AGENDA
Cascade Charter Township Planning Commission
Monday, August 15, 2022
7:00 pm
2870 Jacksmith Ave

STAFF REPORT: Case # 22-3729
REPORT DATE: August 10, 2022
PREPARED FOR: Cascade Charter Township Planning Commission
MEETING DATE: August 15, 2022
PREPARED BY: Brian Hilbrands, Planning Director

REQUESTED ACTION: Site Plan Review for a new two-story, 10,000 sq ft building and parking lot.

**Kuiper Kraemer Building, 6660 Old 28th Street
Site Plan Review**

SITE PLAN
 FOR
6660 OLD 28TH STREET
 CASCADE TOWNSHIP, KENT COUNTY, MICHIGAN

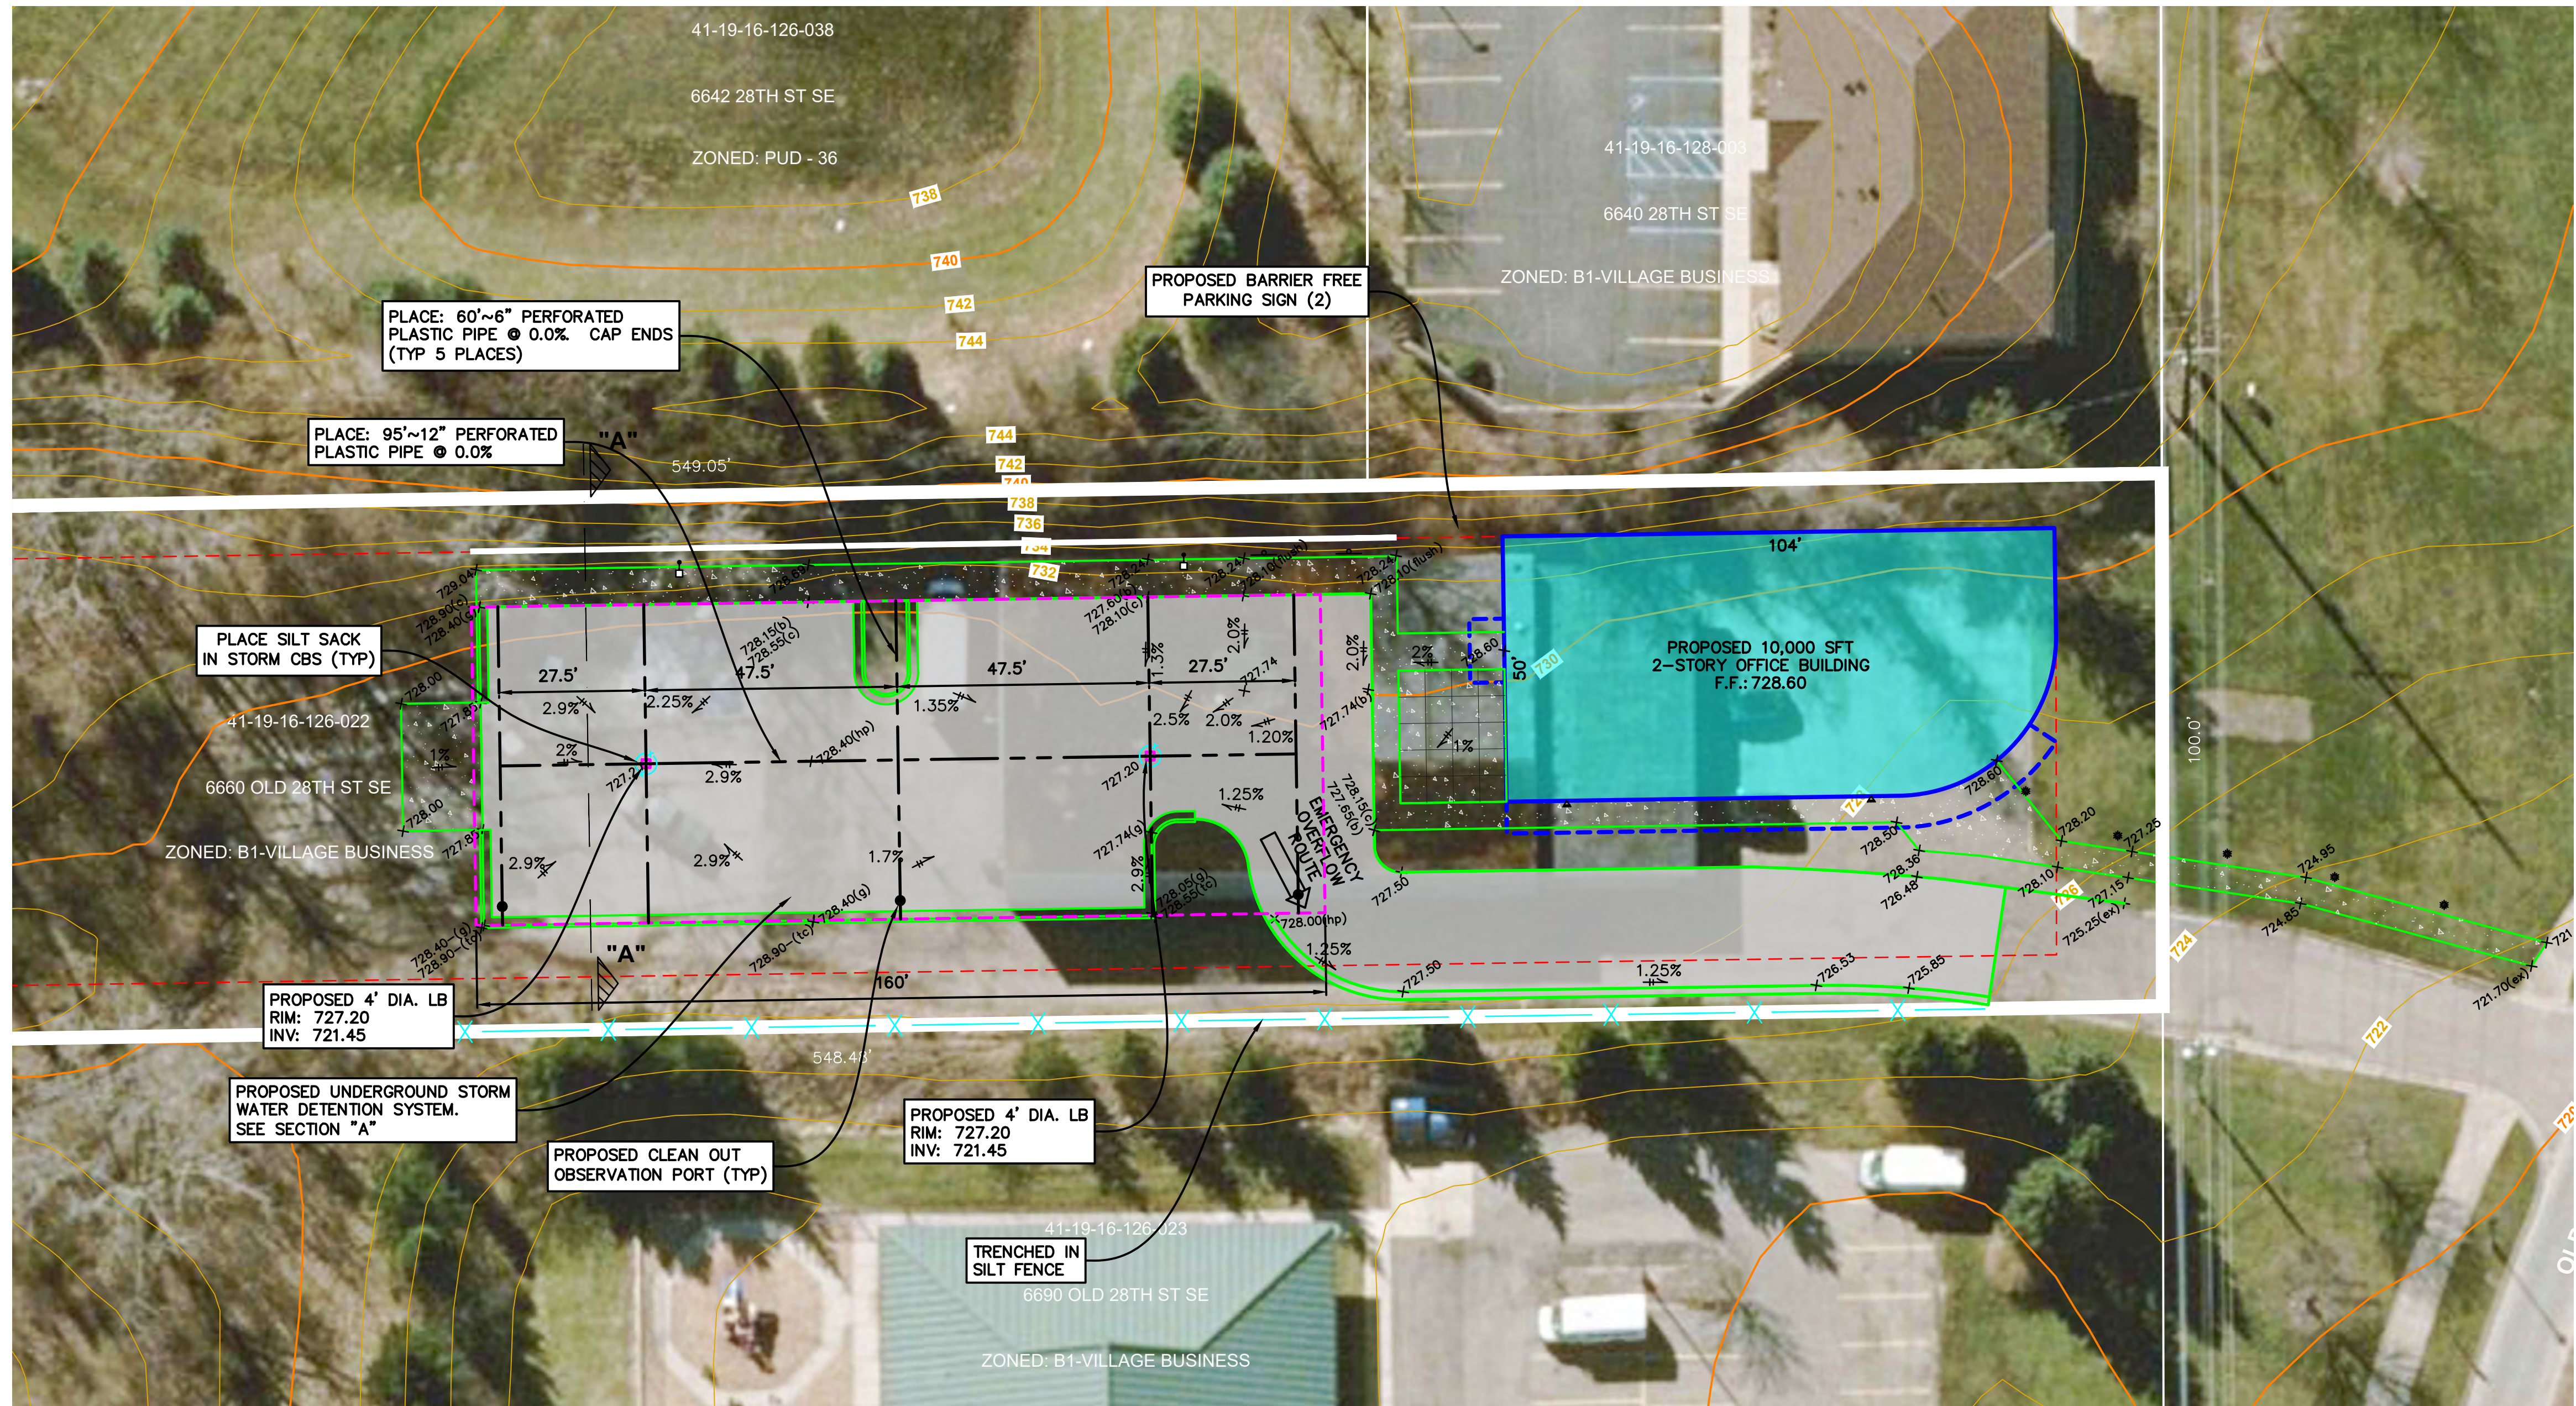
6. The zoning ordinance requires 30 parking spaces to be provided for a 10,000 sq ft office building. There are 31 total parking spaces proposed, with adequate landscaping islands included.

8. The site plan does show a 7' tall retaining wall located along the west property line, which abuts the library property.
9. A 20' bufferyard is required between parking areas and the property lines. Walkways and paths are permitted within the bufferyard, which is why the bufferyard is narrower along the west property line than the east property line. Both sides meet Township requirements.

A new sidewalk is shown connecting the building to the public sidewalk on Old 28th Street. Proposed grades are provided on the plans and the sidewalk is shown as being approximately 7% grade. This is generally acceptable for an accessible sidewalk.

GRADING & UTILITY PLAN
FOR
6660 OLD 28TH STREET
CASCADE TOWNSHIP, KENT COUNTY, MICHIGAN

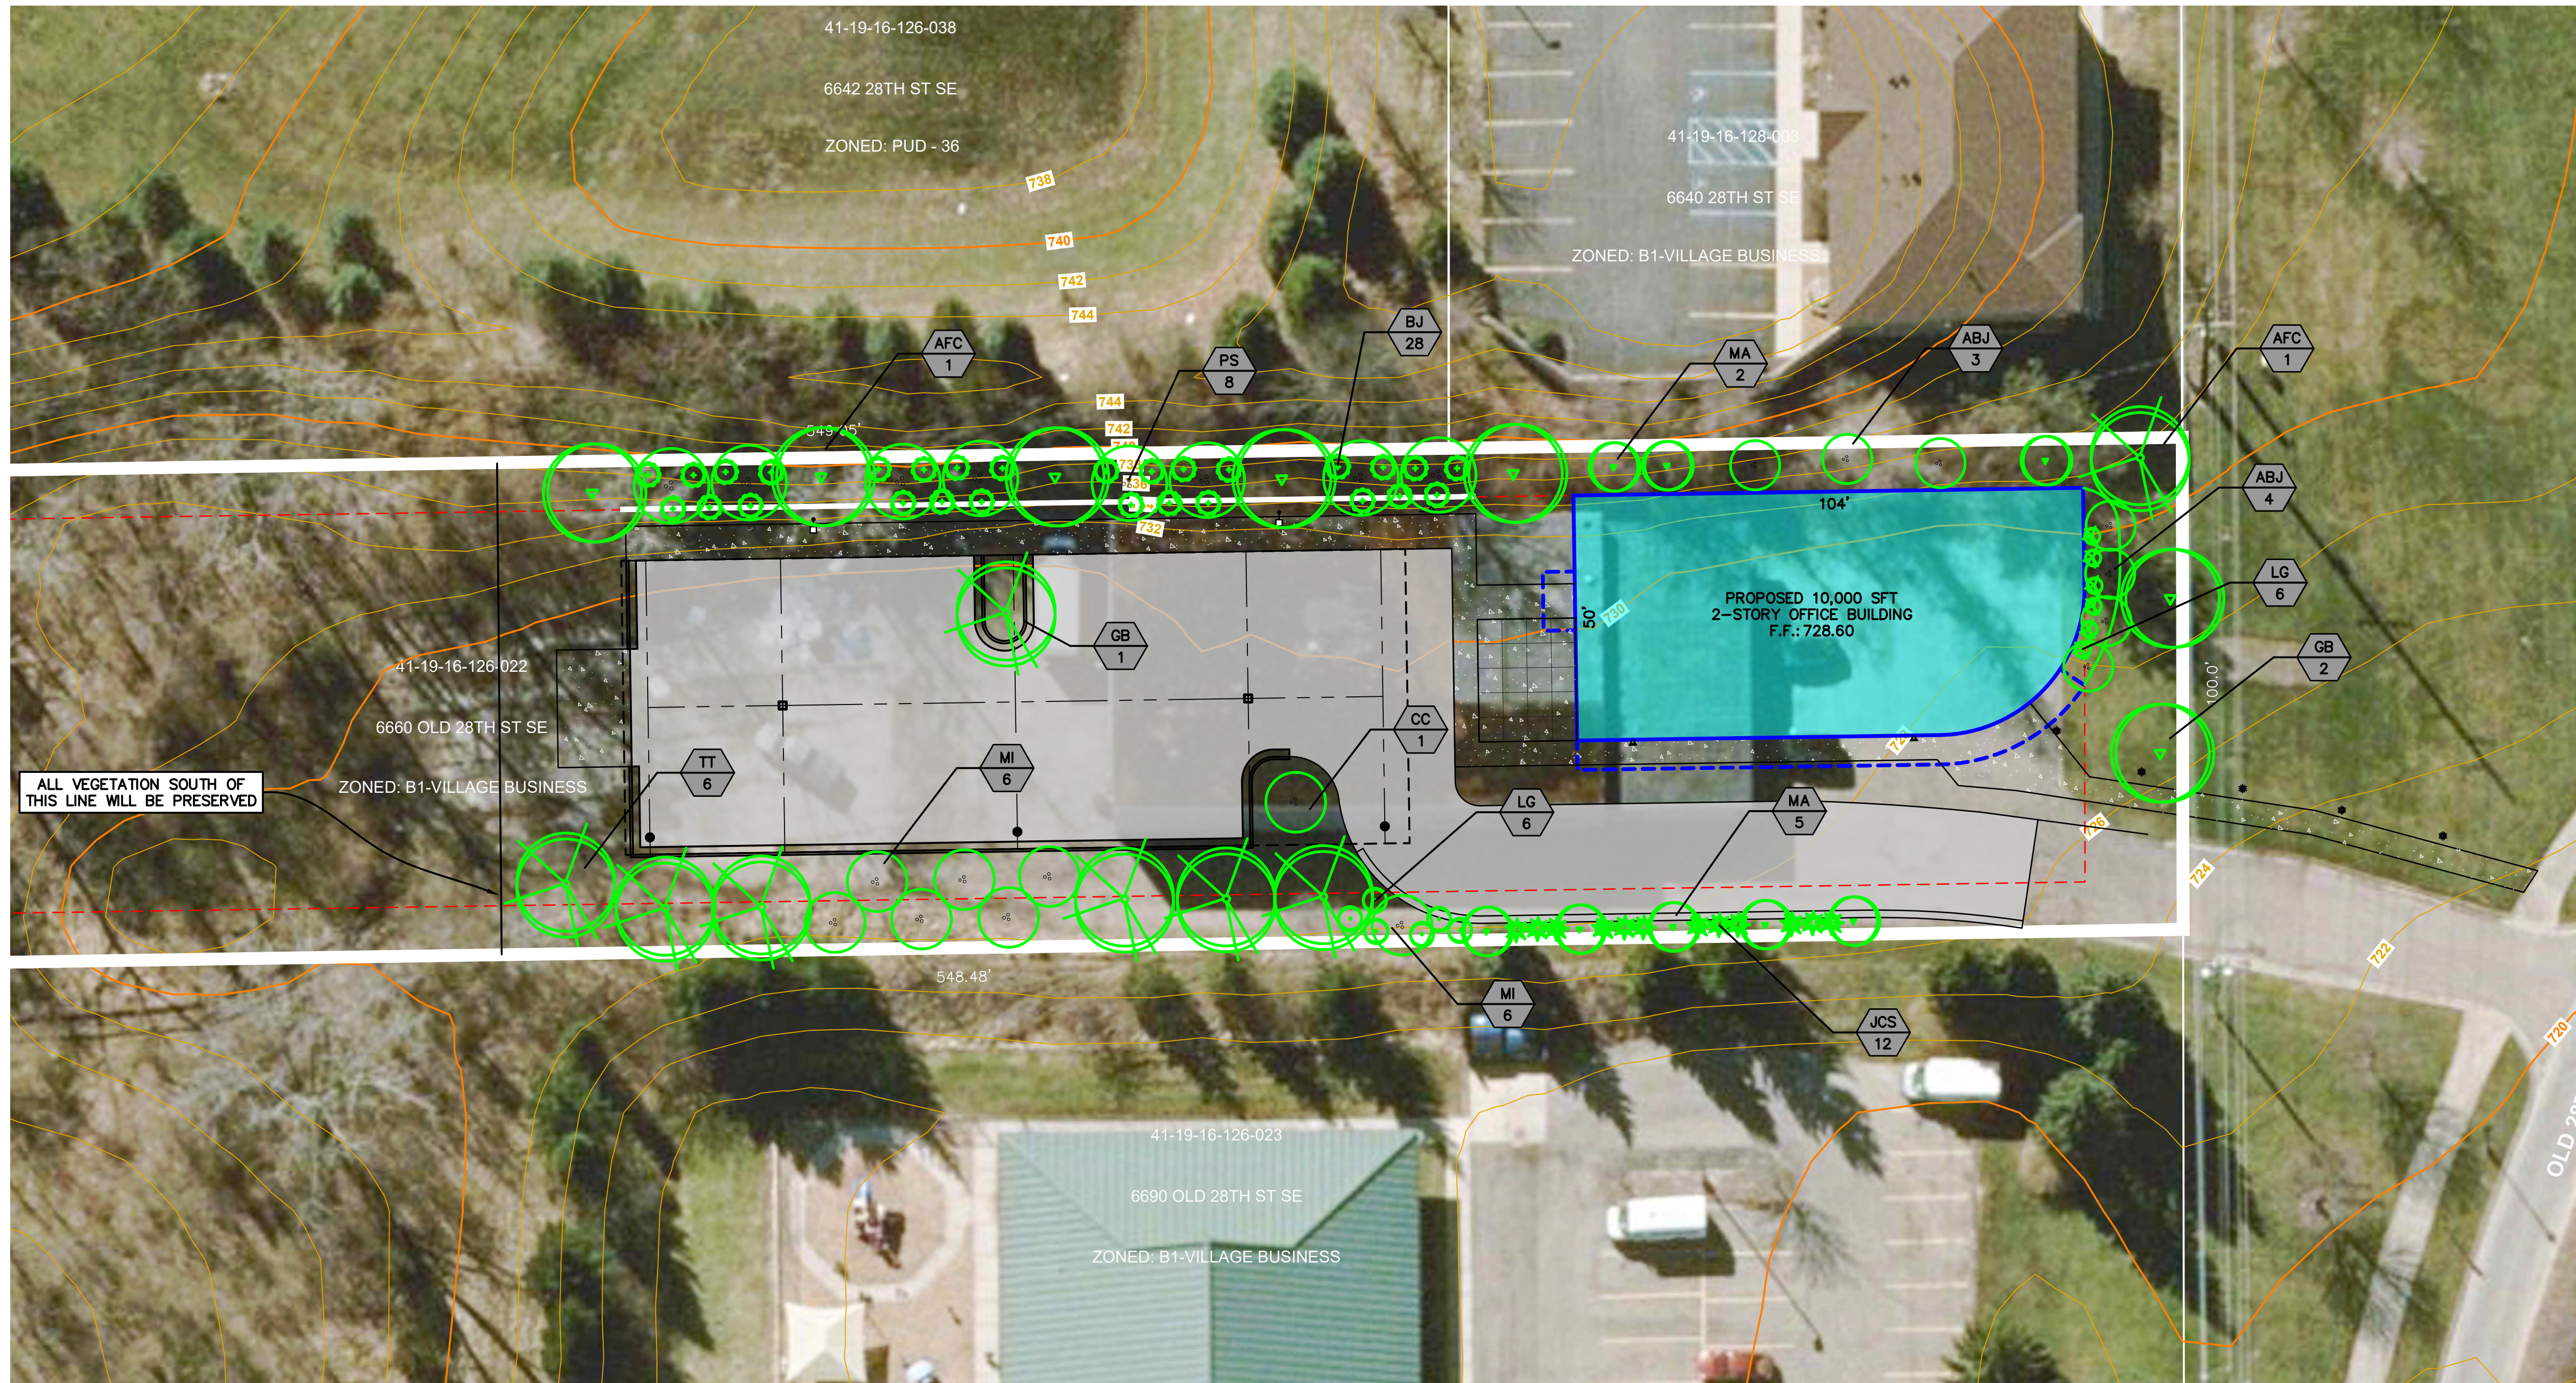
The proposed site plan includes a single 160 feet by 60 feet infiltration bed with a stone depth of 4 feet underneath the parking area at the rear of the site. Two leaching basins with 6 feet deep sumps will serve as inlets and pre-treatment for this system. Perforated pipes at the bottom of the stone layer will serve to spread stored runoff across the bottom of the system. The system has been designed to store and infiltrate the 100-year storm volume with a drawdown time less than the allowable maximum of 72 hours.

The site plan does not include details of the sanitary sewer connection. The developer's engineer indicated the intent is to reuse the existing sanitary sewer lateral that served the previous building with possible modifications on the site to accommodate the new building. There is no intention of running a new service lateral to the sewer main. Any alterations would require approval by the City of Grand Rapids.

SESC measures are provided on the plan drawings. The applicant has included silt fence along the downstream limits of the project. SESC notes include items such as obtaining the SESC permit, including a tracking pad and dust control measures. KCRC may require additional SESC measures beyond what is shown on the drawings.
